PROPOSED IMPROVEMENTS TO STATE ROUTE 9

From US 278/State Route 6 near Pontotoc to US 78 near Sherman
Pontotoc County, Mississippi

State Project No. SP-2833-00(004)/105094-101000

QUESTIONS RECEIVED AS OF JANUARY 14, 2011

Bleeding

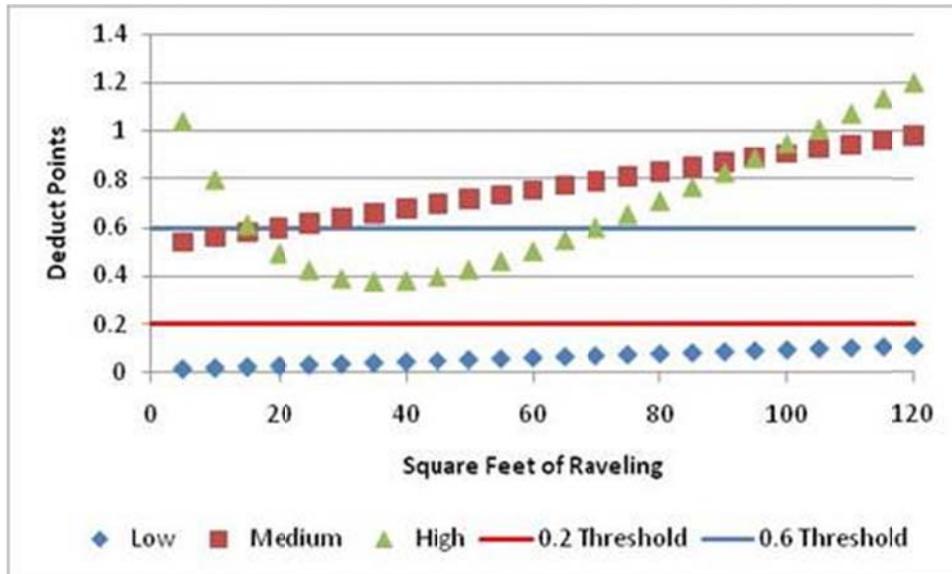
89. The FHWA Distress Identification Manual does not provide degrees of distress for rutting, raveling or bleeding. However, review of the software program DEDUCT CURVE VIEWER v2.0 indicates severity levels of low, medium and high for these distresses. Will MDOT provide guidance on the delineation for these distresses for a visual condition survey?

Low Severity is surface area that is discolored relative to surrounding pavement due to excess asphalt

Medium Severity is surface area that is losing surface texture due to excess asphalt
